***Docket Item #7 A-E - The Calvert Apartments
 Master Plan Amendment #2009-0005
 Rezoning #2009-0003
 Development Special Use Permit #2009-0006
 Transportation Management Plan #2010-0002
 Vacation #2009-0001***

Application	General Data	
Project Name: The Calvert Apartments Location: 3110 Mount Vernon Avenue Applicant: UDR Calvert, LLC Represented by Duncan Blair	PC Hearing:	September 7, 2010
	CC Hearing:	September 25, 2010
	If approved, DSUP Expiration:	September 25, 2013 (36 months)
	Plan Acreage:	3.41 acres 3.49 acres (with vacation)
	Zone:	CRMU-M
	Proposed Use:	Residential with retail
	Gross Floor Area:	Residential: 283,426 sf Retail: 10,914 sf Total: 294,340 sf
	Dwelling Units:	Existing: 187 Units Proposed: 332 Units
	Small Area Plan:	Potomac West
	Green Building:	Compliance with Green Building Policy – LEED Certification

Staff Recommendation: APPROVAL WITH CONDITIONS
Staff Reviewers: Katy Parker, AICP, LEED AP katy.parker@alexandriava.gov Gary Wagner, RLA gary.wagner@alexandriava.gov

Attachment #2– Revised design for the plaza and entrance to high-rise

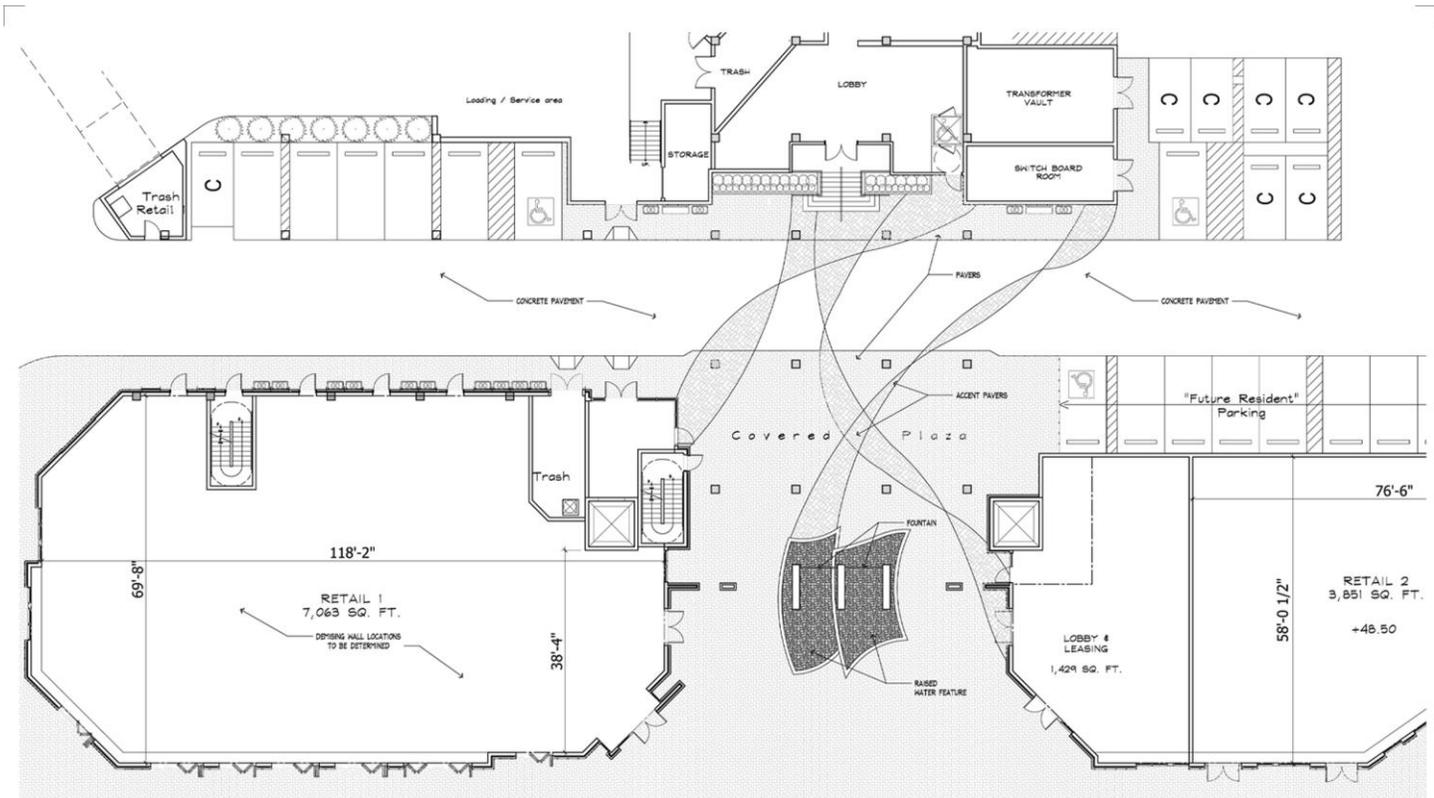
10. Provide the following building refinements to the satisfaction of the Director of P&Z:
 - a. Continue to refine the area between the street level plaza and the entrance to the high rise through the garage to provide a more inviting and pedestrian friendly environment. The area should be generally consistent with *Attachment #2* and consider the following for the final design:

- i. Provide adequate lighting for the area and incorporate it into the design;
 - ii. Design the treatment of the piers to be compatible with the overall design.
